Client: C.Reiss Project: Dock

Subject: RE: Action Requested by 01/31/2024, C. Reiss , 02-16-589248: Supplemental Site Investigation Report

Attachments:
 C.Reiss Stormwater Pond Construction.pdf

Photograph ID: 2

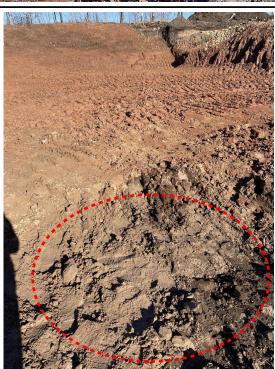
Sand below Clay Liner
